Environmental Monitoring Works for Contract No. ED/2018/01 – Kai Tak Development – Stage 4 infrastructure at the Former Runway and South Apron

Submission of Landscape Mitigation Plan (Revision 2)

SUBMISSION REVIEW FORM

Landscape Mitigation Plan

Elevated Landscaped Deck

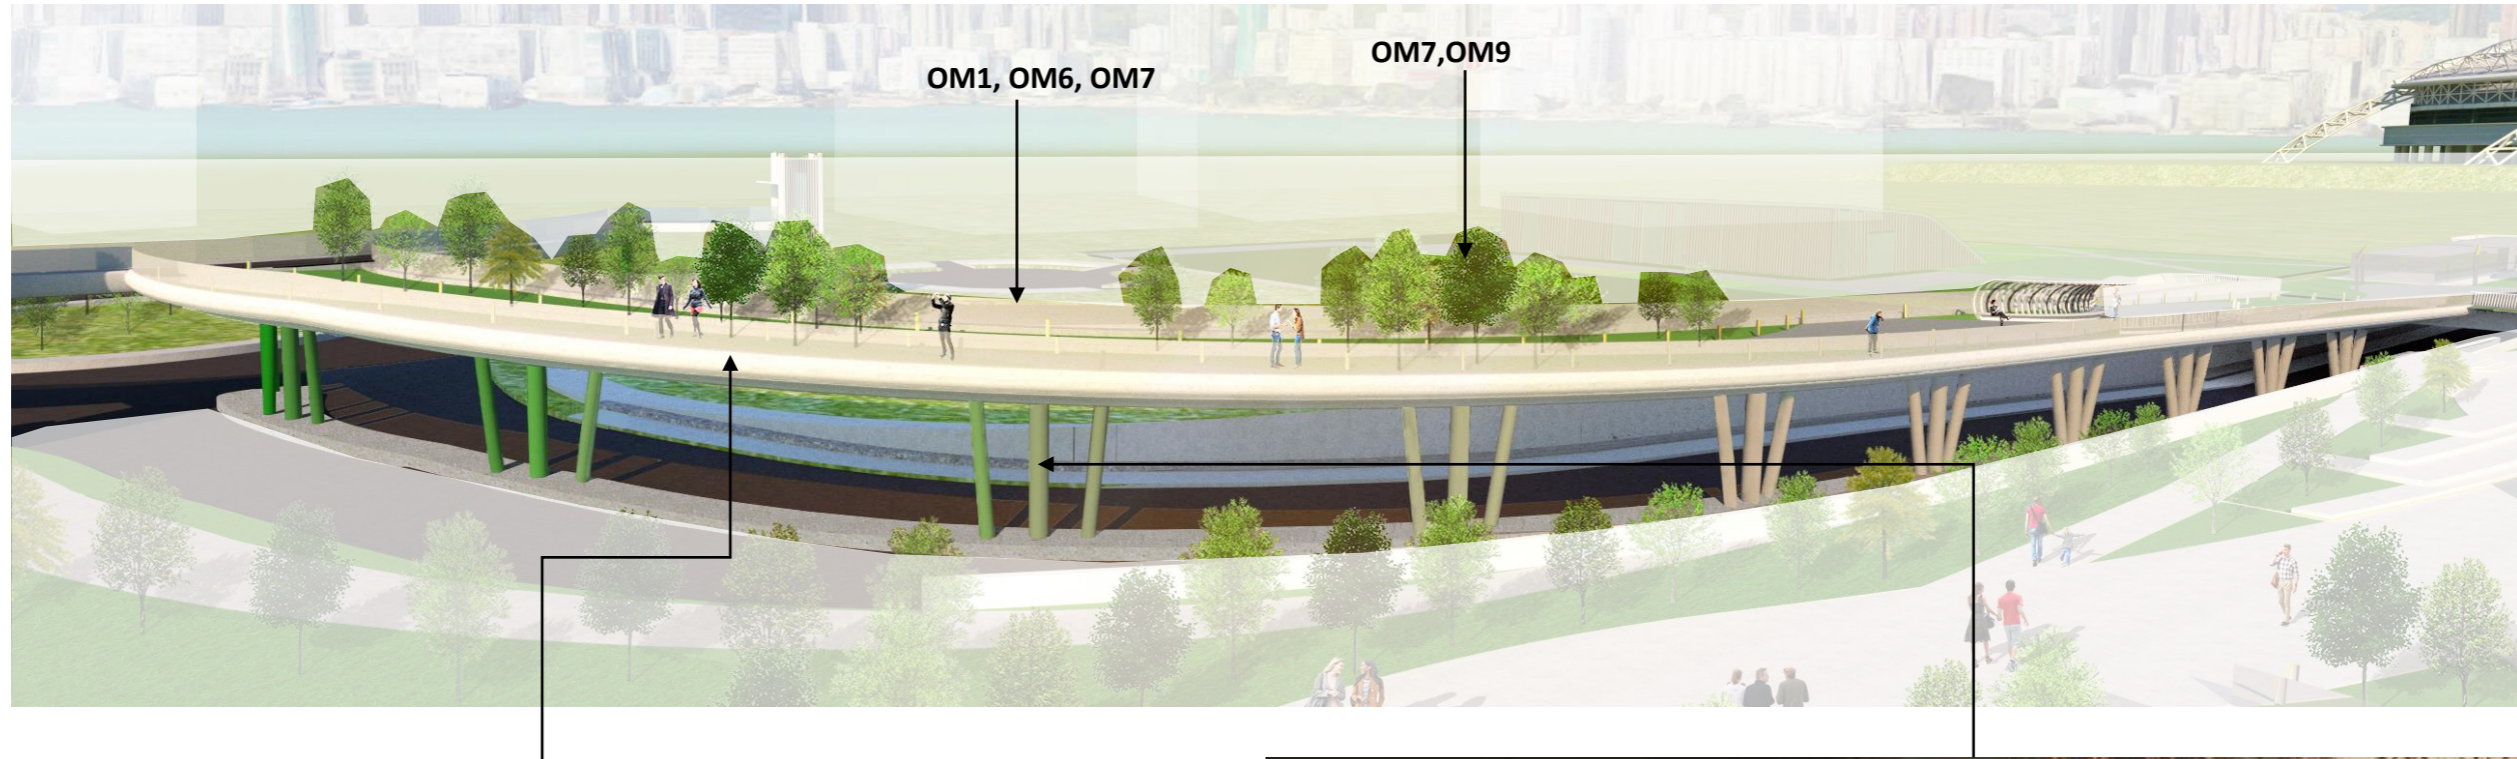
9.	EPD	<u>Visual Impact</u>	(ii) There is no information regarding the form, color and surface details of the elevated landscaped deck. Besides Figure 56, the Consultant may consider providing visual illustration(s) showing a more close-up view of the landscape deck.	Noted. Please be informed the form, color and surface details of the elevated landscaped deck's design shall be in line with the design under Contract No. KL/2014/01, Kai Tak development – stage 2 infrastructure at north apron area of Kai Tak Airport. Hence close-up photos of Stage 2's elevated landscaped deck have been

ITEM NO.	REVIEWER	DOCUMENT REFERENCE	REVIEWER'S COMMENT	OUR RESPONSE
				provided in Figure 57 for reference.
10.	EPD	<u>Visual Impact</u>	Paragraph 2.2.9, Figures 20 & 55 - The trellis seating at the elevated landscaped deck as stated in Line 7 is not shown in Figures 20 and 55.	Noted. The trellis seating at the elevated landscaped deck is shown in Figures 20 and 55 in this submission.
11.	EPD	<u>Visual Impact</u>	Figure 11 - Please consider annotating the observation deck in Figure 22.	Noted. 'Observation Deck' has been annotated in Figure 11.
